MONITORING YEAR 3 ANNUAL REPORT FINAL

SANDY BRANCH MITIGATION SITE

RE: DMS Comments on the MY3 Report
Sandy Branch, Project ID #100060, DMS Contract 7527

Figure 1. Current Condition Plan View
 Sandy Branch Mitigation Site
 DMS Project No. 100060
 Monitoring Year 3 - 2023

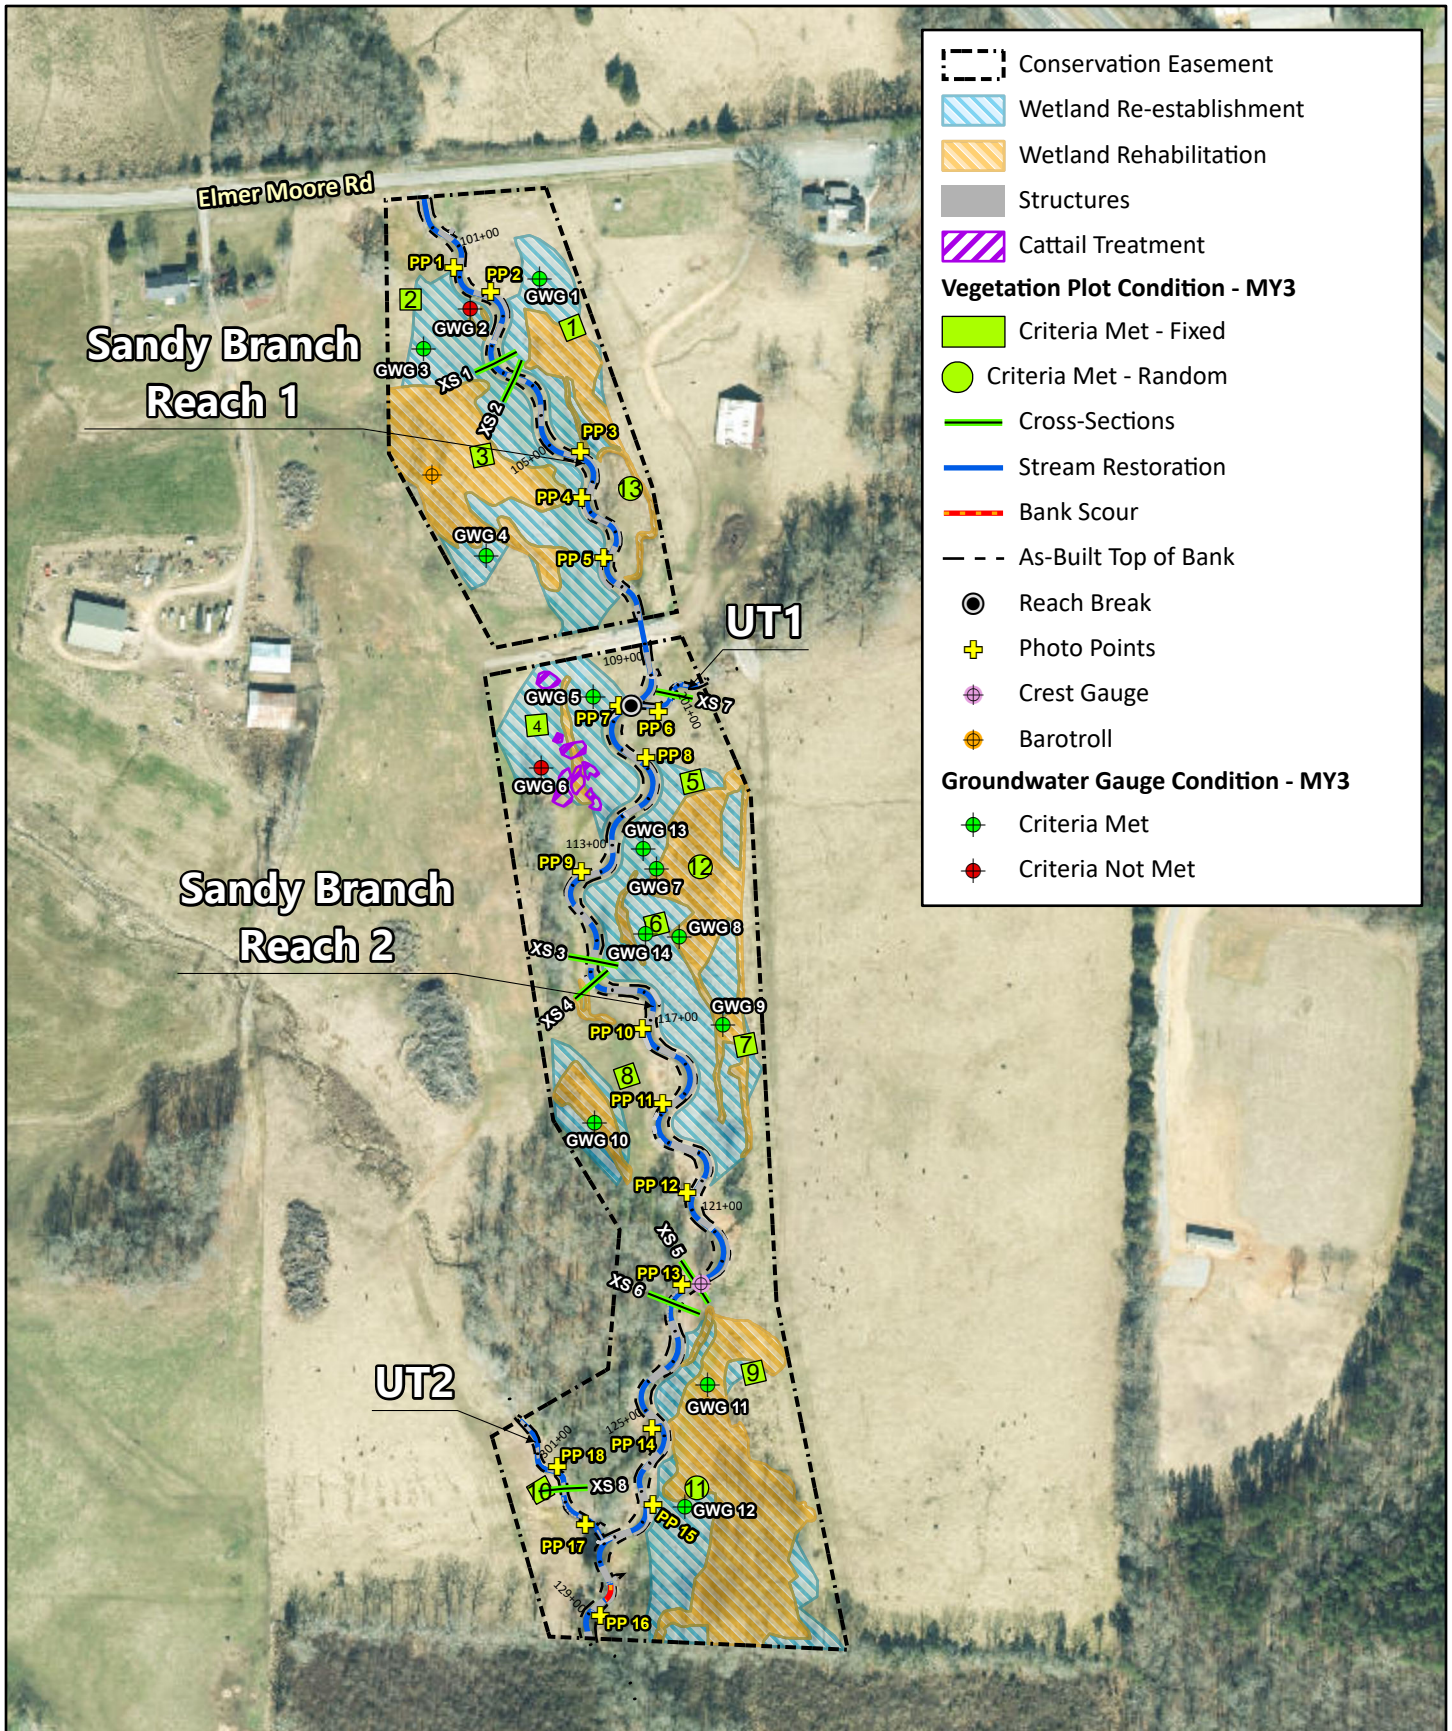
1. Section 2.2 states multiflora rose and privet were treated 'within the existing forested area along the lower portion of Sandy Branch Reach 2...' Were these scattered, individual sprouts or mappable treatment areas? Please add to CCPV if needed.

3. Recent scour on the outer bank in a meander was brought to DMS' attention at the 1/26/2024 site visit, located a short distance upstream of PP16. Please call out location on CCPV and discuss remedial actions taken, if any, in the MY4 report.

Response: These were scattered, individual sprouts outside of the mapping threshold. This has been clarified in the MY3 report text.

Response: The location of scour on the outside bank of a meander on Sandy Branch Reach 2 has been added to the CCPV, and text has been added to the report. Linear stream footage of the scour has been added to Table 4. Any remedial actions taken will be discussed in the MY4 report.
